NMA Design Amendments

Detail Section and Elevation
drawing title: Block A Apartment Sheet 1
Reading Borough Council
Dwyer Road
client / project

HTA-A_DR_0603
drawing number

Block A
Detail Elevation 1 - Balcony & Communal Entrance

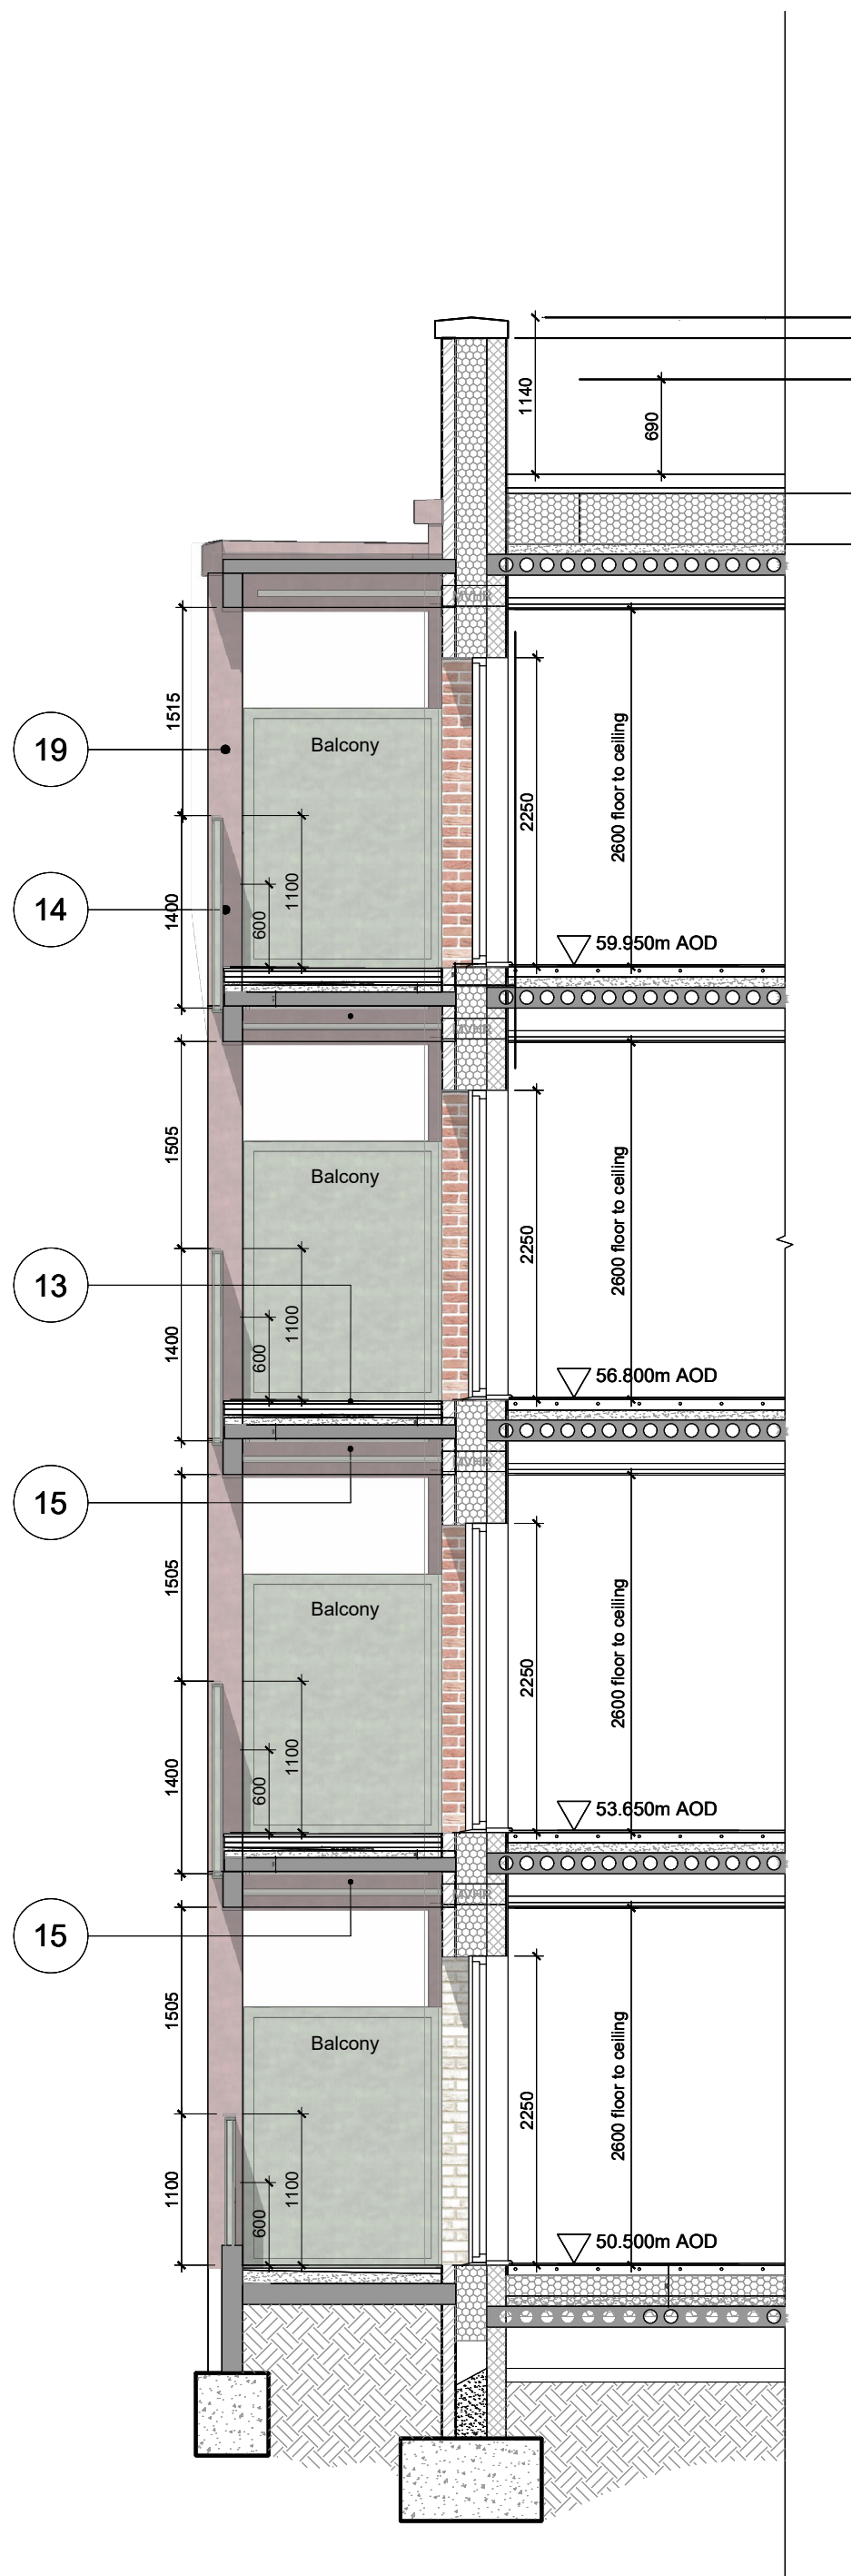
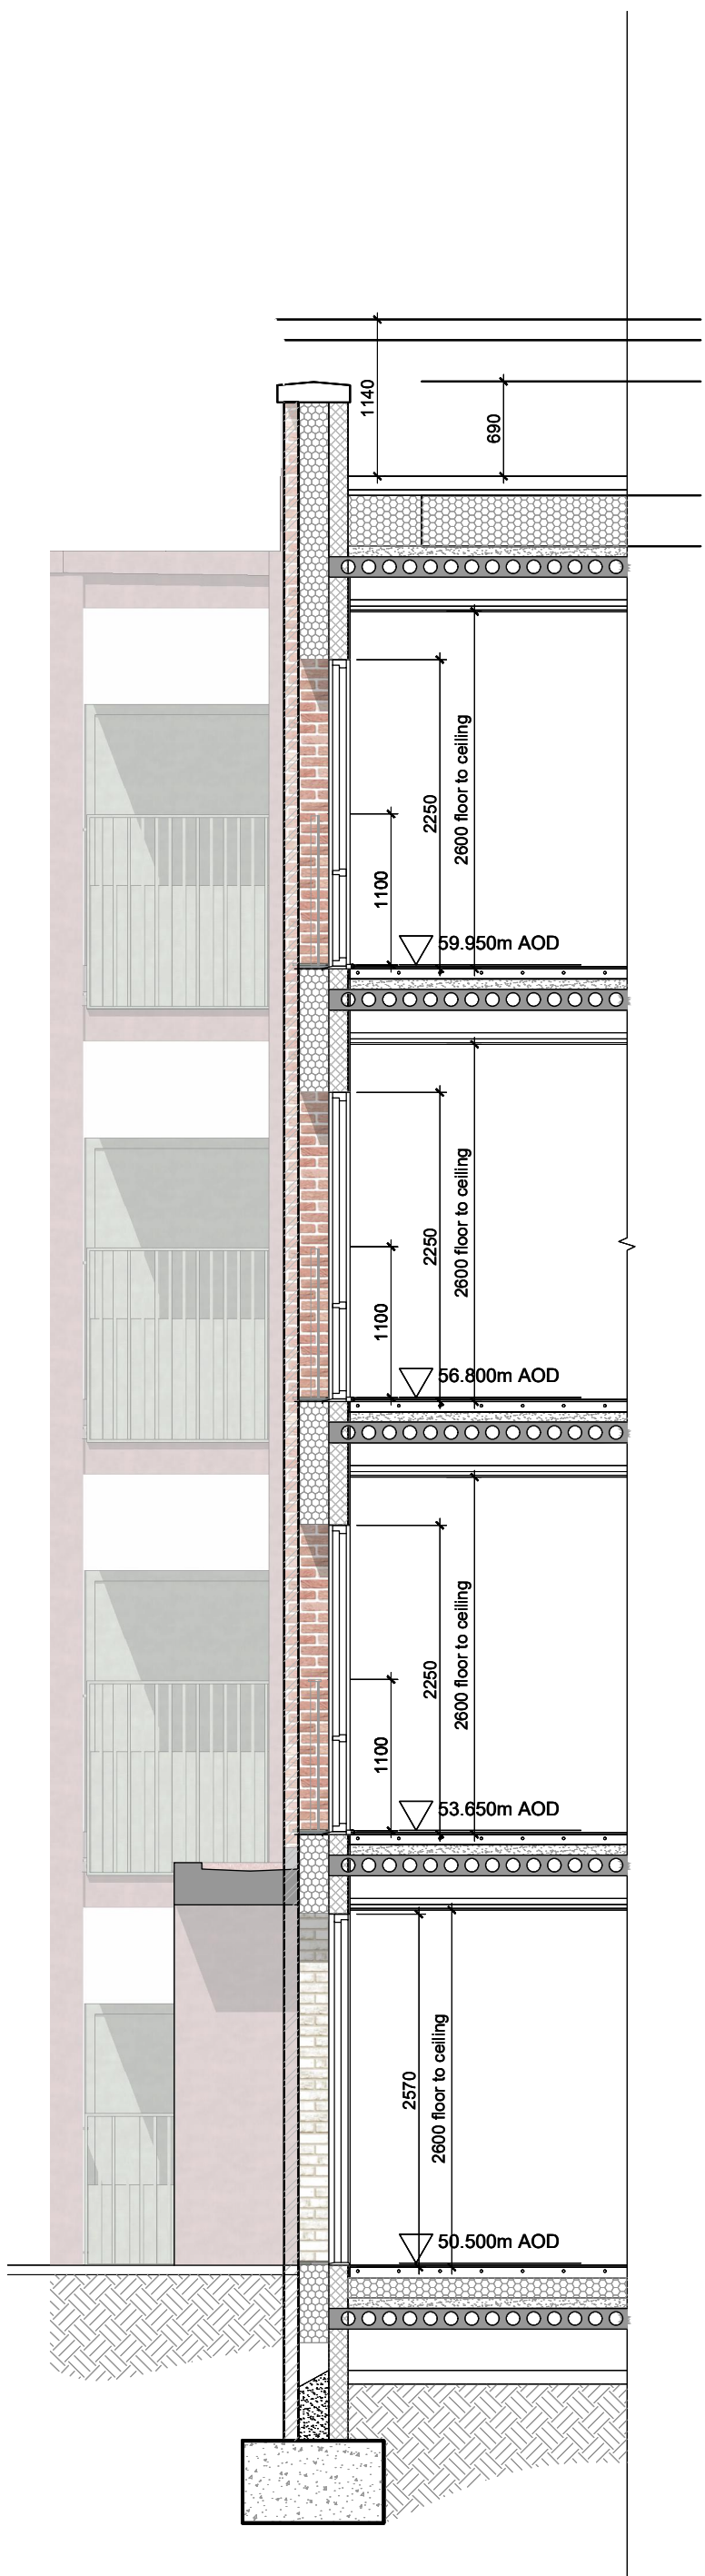
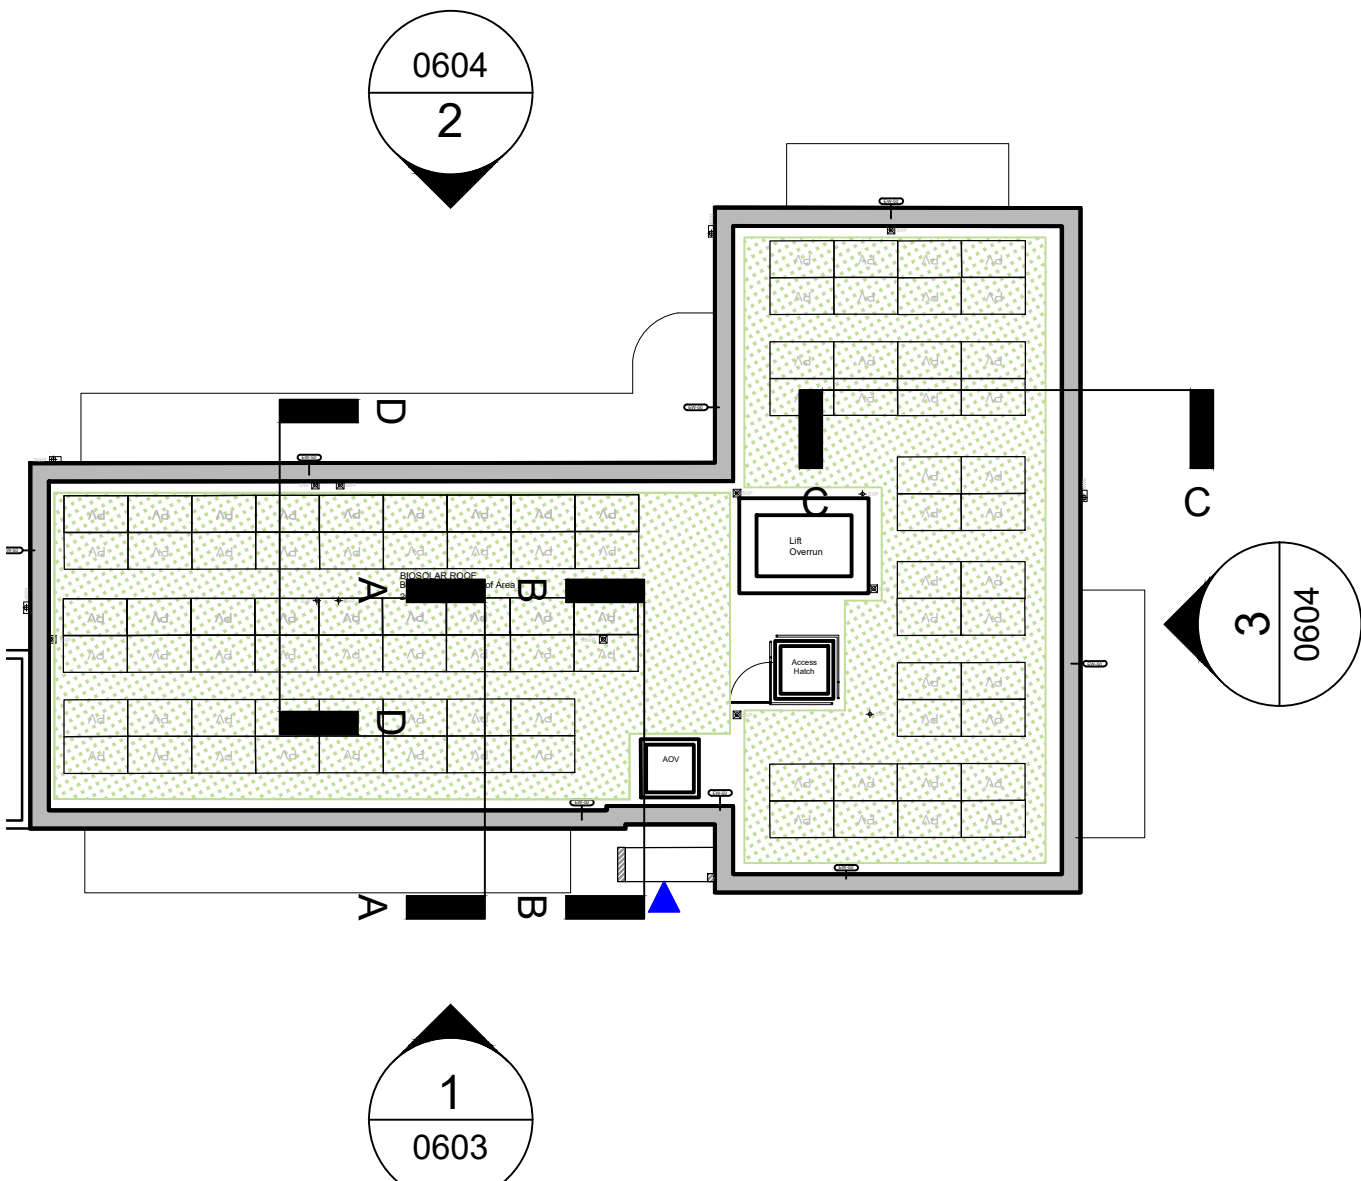
- 1) Deck and balustrade structural frame changed from pre-cast concrete to painted steel
- 2) Communal window revised to remove Juliette balcony, to include opening lights with fixed lower panes
- 3) Communal entrance component revised to reduce width of door set and omit fixed metal panel in favour of brickwork
- 4) Communal entrance canopy revised to omit pre-cast concrete and match proposed painted steel elsewhere
- 5) Minor amendments to window and door setting out, to reflect plan refinements
- 6) Minor amendments to rainwater pipe hopper locations at roof level
